RE: Plant Evaluation of Rotary Dryer Equipment

ASPHALT DRYER – PLANT EVALUATION

ASPHALT DRYER – Joliet PLANT EVALUATION

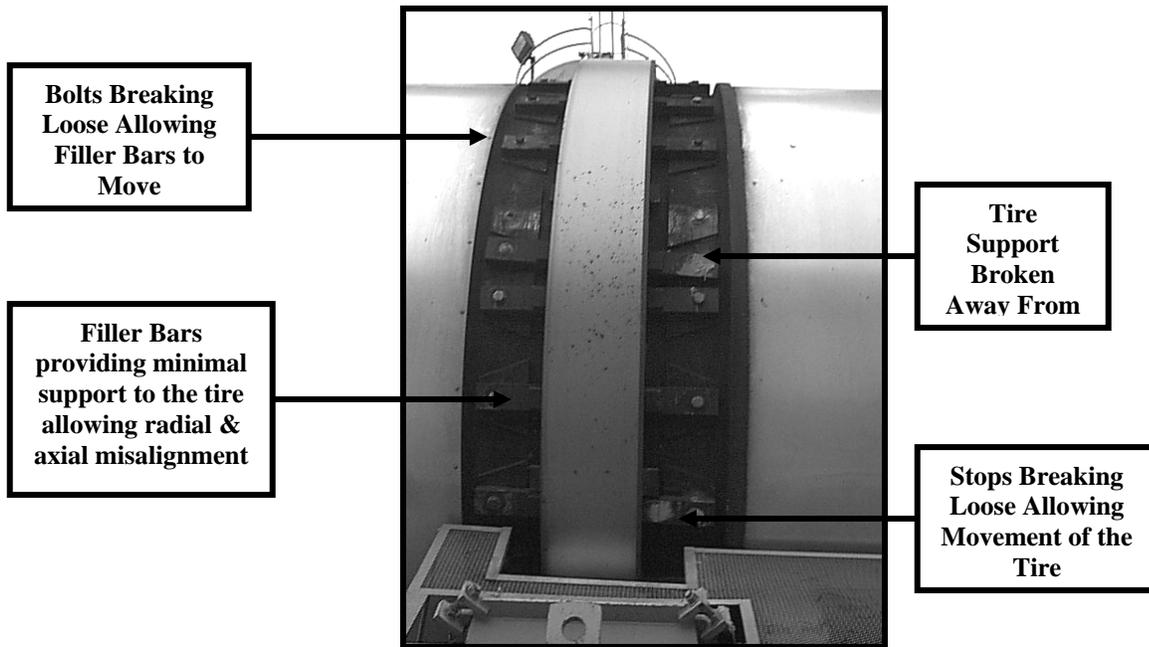
ISSUE:

The dryer was thrusting hard on the downhill thrust idler. Understandably, asphalt dryers cannot be expected to “float” between the thrust idlers due to the variance in mix designs, material feed and rates of production. Never the less, the drum should not be allowed to ride hard upon either of the thrust idlers.

Alignment of the vessel should be accomplished while running the “average” production load, allowing for movement of the drum for extremes on both ends of the spectrum. Some contact with the thrust idlers is unavoidable, but should only be light contact and not supporting the entire weight of the drum and the material. Light grinding of the tires and trunnions may be required to properly align the vessel.

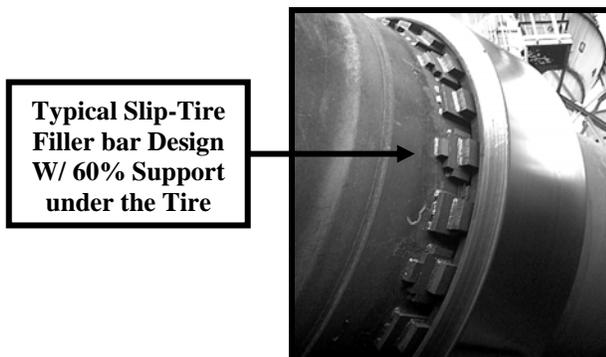
The tire support system at the inlet tire is failing and should be looked at for replacement at the next opportunity.

Remove the existing anti-rotation tire support design, and replace it with a fully supported slip tire design. This design provides much better support to the underside of the tire, preventing premature movement of the tire in the axial & radial alignment to the centerline of the drum. Removal of the anti-rotation stops will stop the tire from peeling away the filler bars every time the tire attempts to creep.

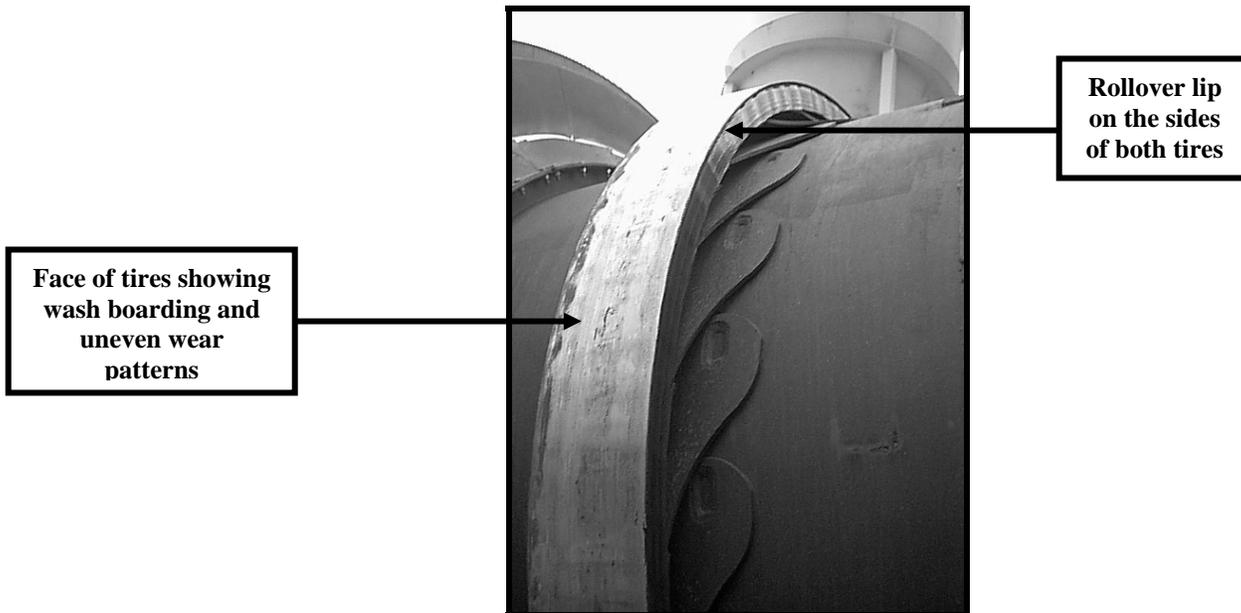
The unit appears to be holding up well considering the age of the drum. The sprung tire support design is appropriate for the application and appears to be adequately supporting the tire.

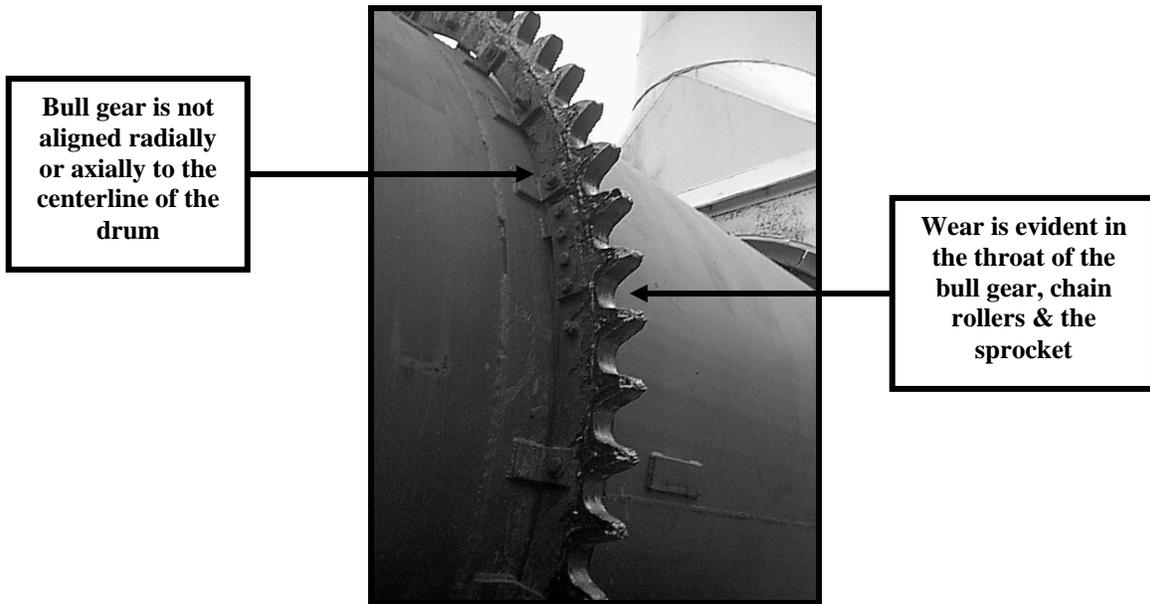
Both tires are showing considerable wear with approximately ½” rollover on the sides of the tires. The trunnions appear to be worn out. Testing of the tires and trunnions revealed the following information:

TIRE HARDNESS: 285/325 BRINEL

TRUNNION HARDNESS: 475/550 BRINEL

The trunnions should be replaced with new or reconditions assemblies. Bearings should be replaced and housings cleaned, inspected and replaced as necessary.

Both tires should be ground to reestablish axial & radial alignment to the centerline of the drum, with taper, concave or convex conditions removed from the faces of the tires.

Alignment of the vessel should be accomplished while running the “average” production load, allowing for movement of the drum for extremes on both ends of the spectrum. Some contact with the thrust idlers is unavoidable, but should only be light contact and not supporting the entire weight of the drum and the material.
